To: Development Permit Panel

File: DP 23-025993

Re: **Application by Anthony Boni (Boni Maddison Architects) for a Development Permit at 4831 Steveston Highway**

TITLE:
GARBAGE/RECYCLING/BIKES

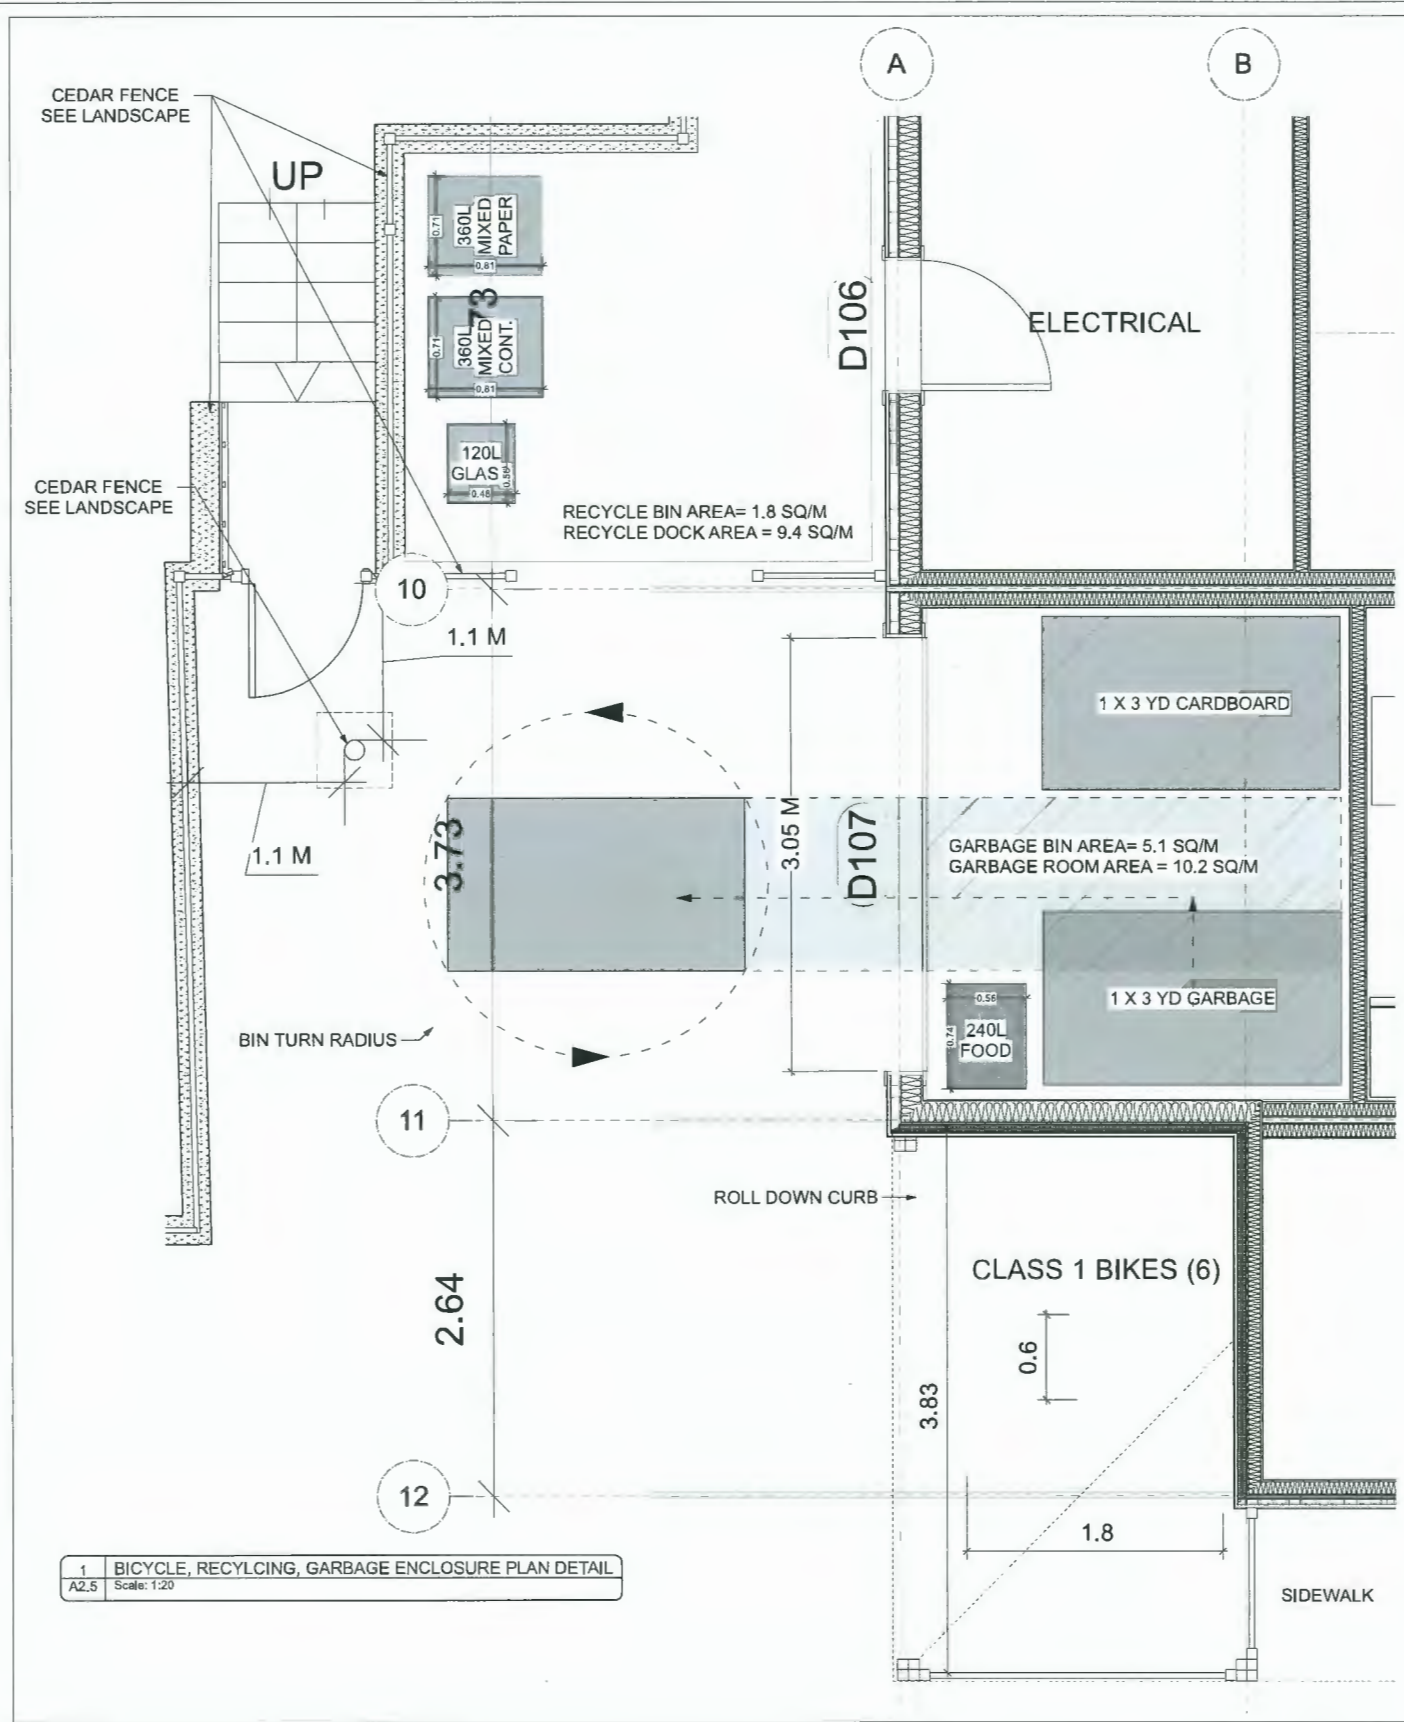
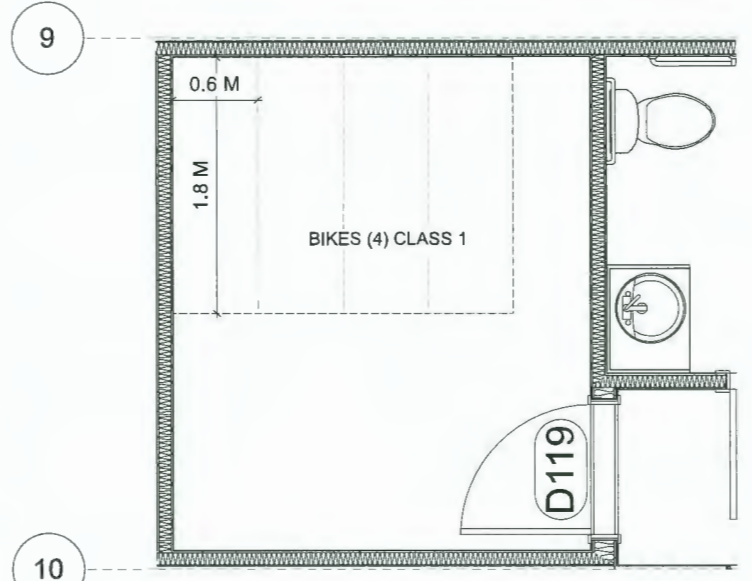
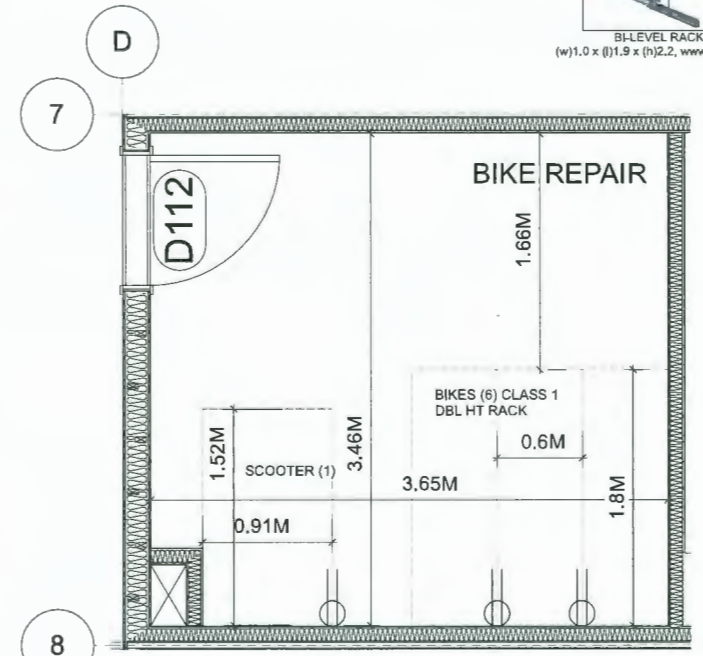
- Direct connection of the site to the Railway Greenway.
- Redesign the bicycle parking to provide more bicycle parking opportunities for the residents.

- Bicycle parking: The applicant proposes to provide the required ten resident bicycle parking spaces (Class 1) and eight visitor bicycle parking spaces (Class 2). The applicant is also proposing six additional resident bicycle parking spaces (Class 1) above the bicycle parking requirement, making for a total of 16 resident bicycle parking spaces (Class 1).

TITLE:
MATERIALS SHEET

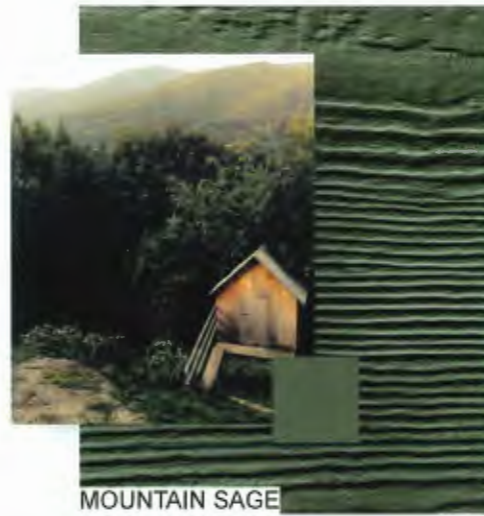
- clarify the use of materials in the renderings provided by the applicant, e.g. the use of board and batten and lap siding.

Correct some finishes were not clearly represented. The intent is that the darker green at the base and at gables is all board and batten. The lighter green is all horizontal lap siding

Drawing title: Tree Management Plan
 Project address: 4831 Steveston Hwy, Richmond BC
 Client: CPA Development

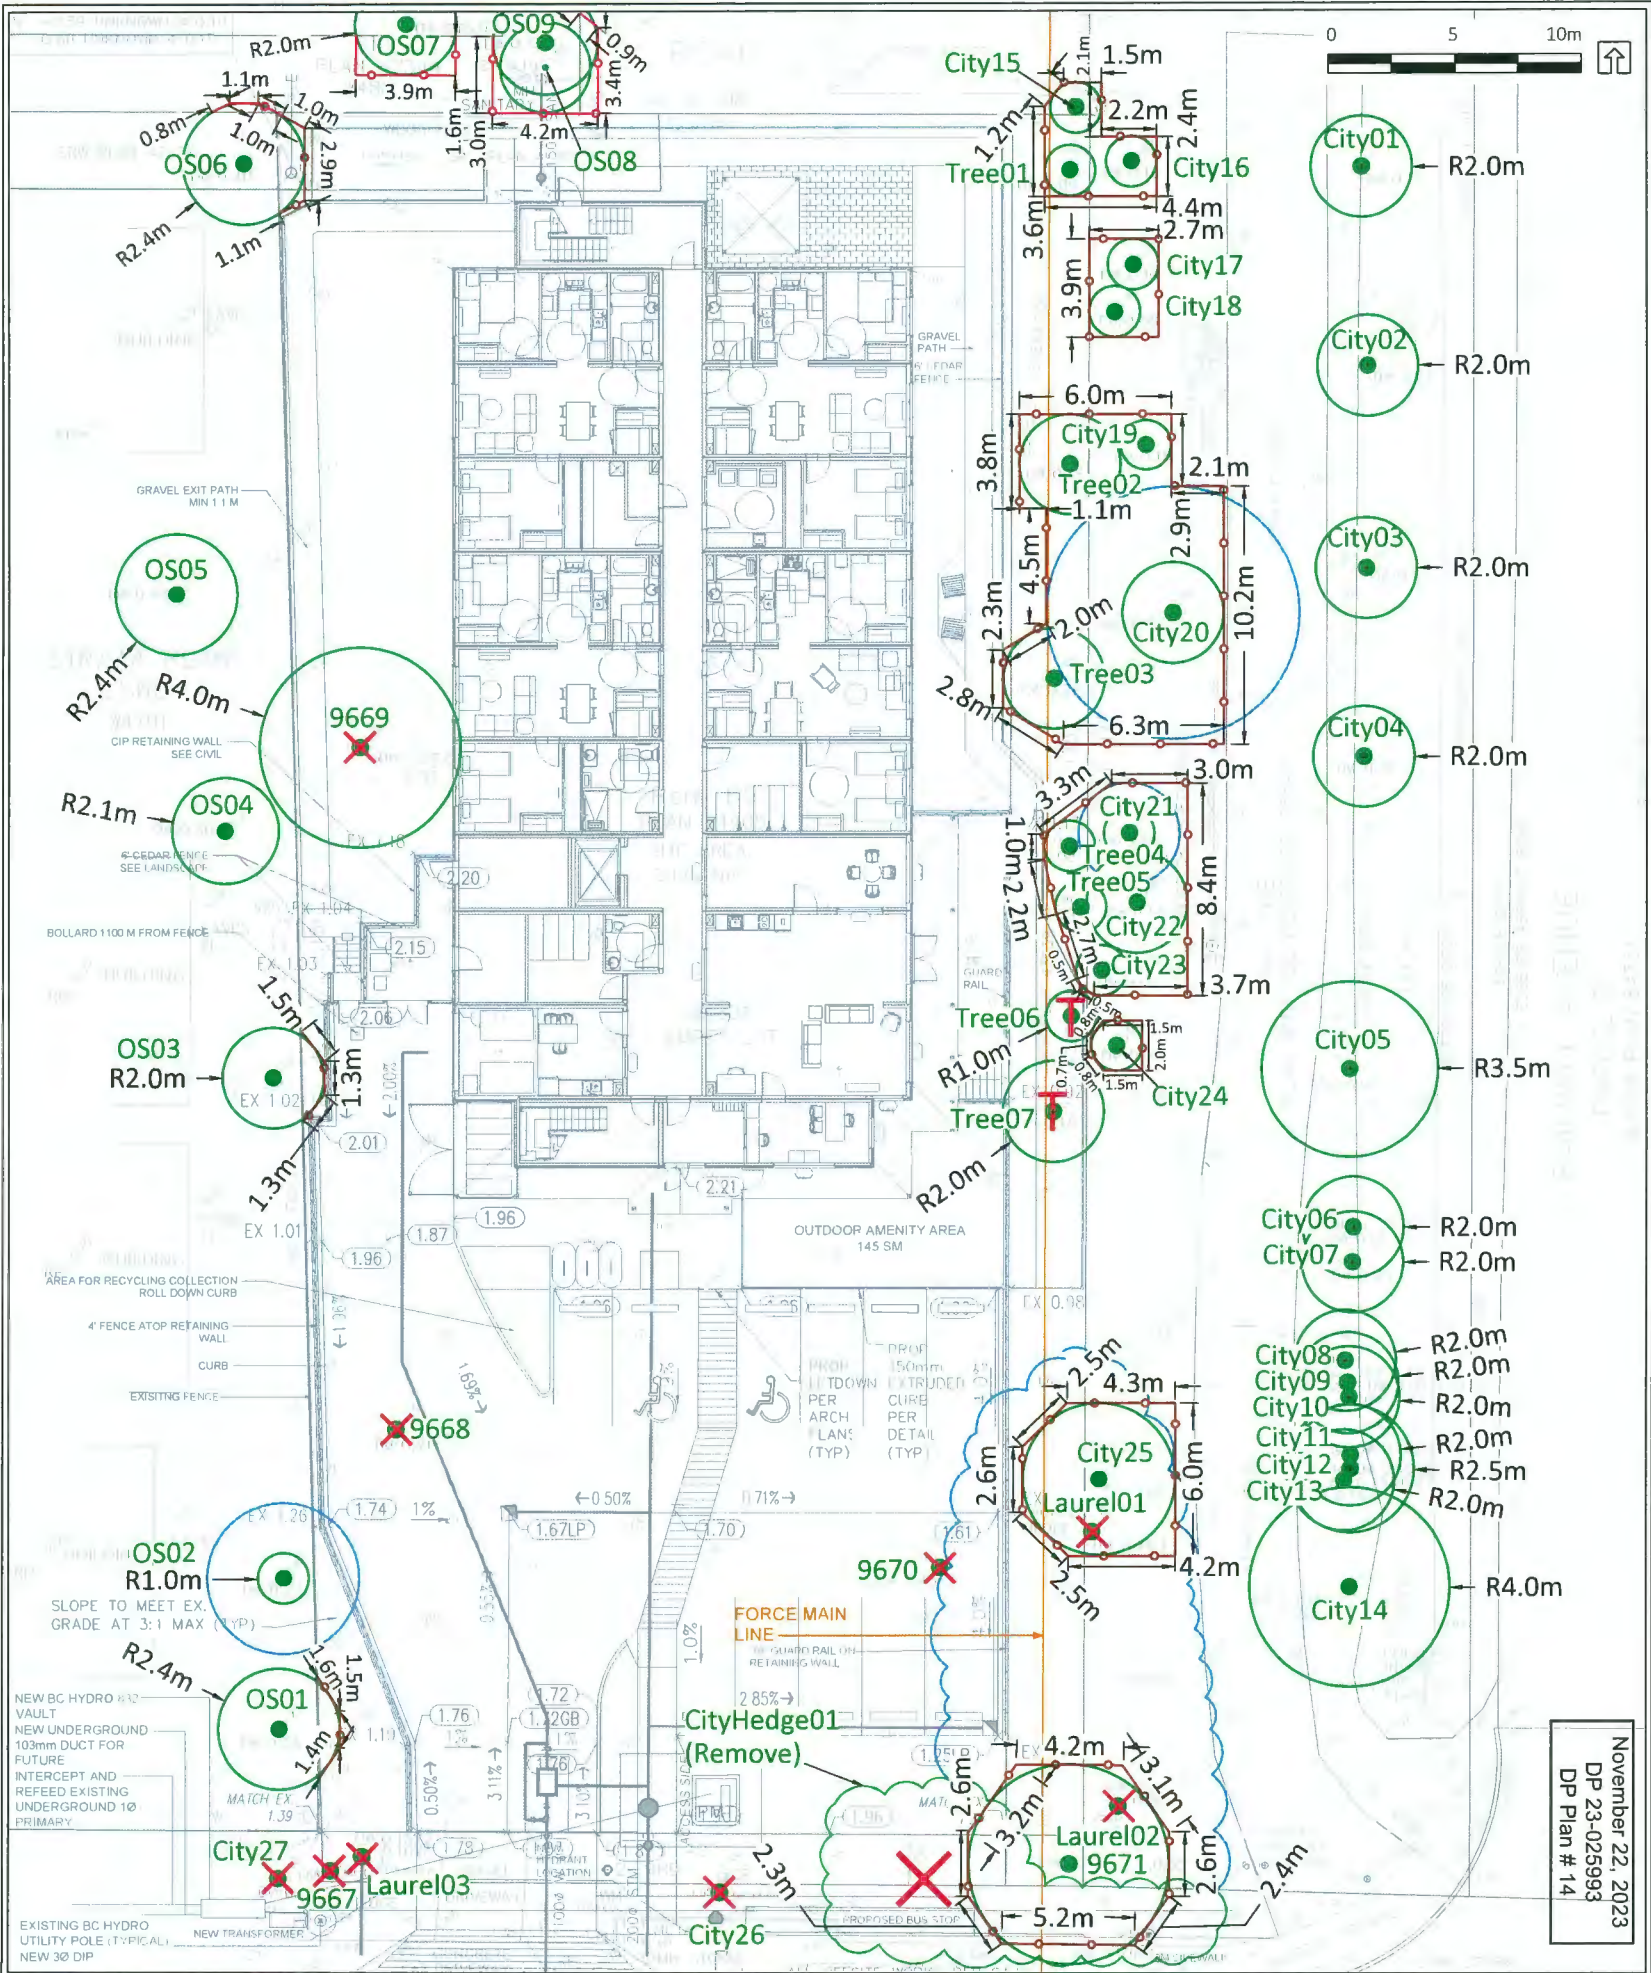
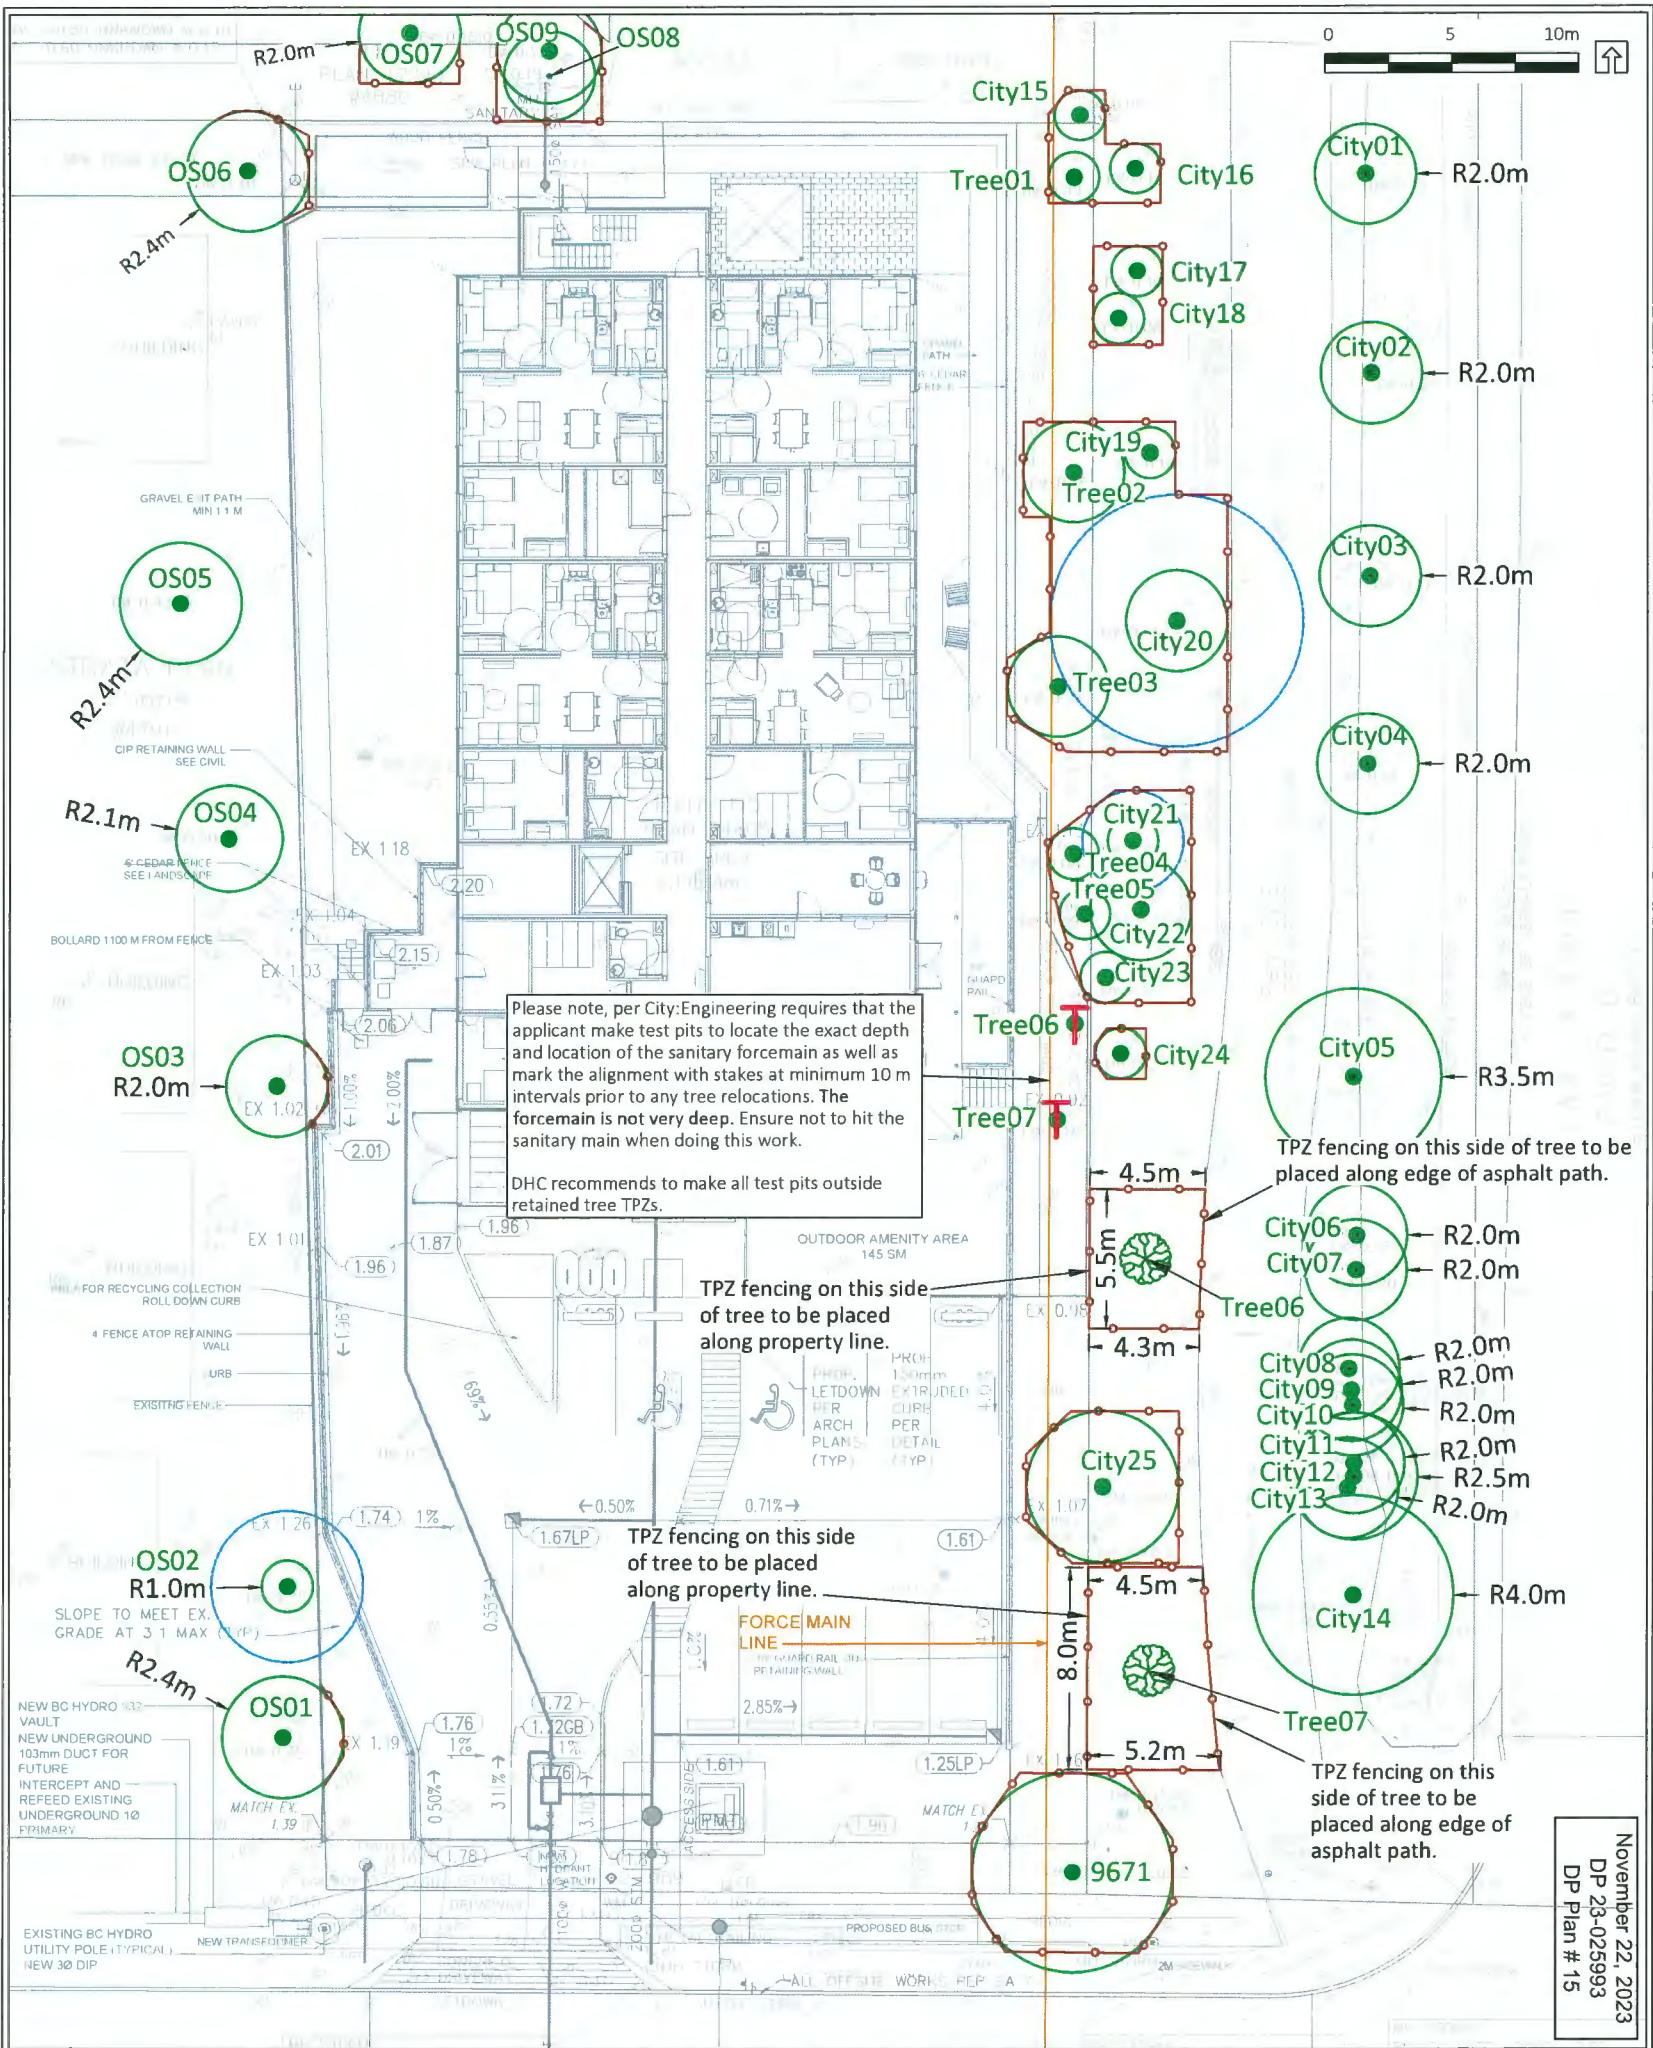
- Tree preservation was reviewed at the rezoning stage, at that time, the applicant intended to remove three on-site trees (tag# 9668, 9669 and 9670). Tree preservation was further reviewed as part of the Development Permit application, and two off-site city trees (tag# City27 and 9667) by the southwest corner of the site have been further identified for removal trees. The additional tree removal is required to accommodate site planning requirements associated with the installation of BC Hydro infrastructure.

- A total of five trees are now proposed for removal. The Official Community Plan (OCP) requires a 2:1 replacement ratio for the trees removed, therefore requiring a total of ten replacement trees. The applicant is proposing to plant a total of 12 trees on-site, which exceeds the 2:1 replacement requirement established in the OCP.

- Proof of a contract with a company specializing in tree relocation to undertake the transplant of the two trees (tag# Tree06 and Tree07) will be required prior to any site preparation or construction activities, including building demolition, occurring on-site.
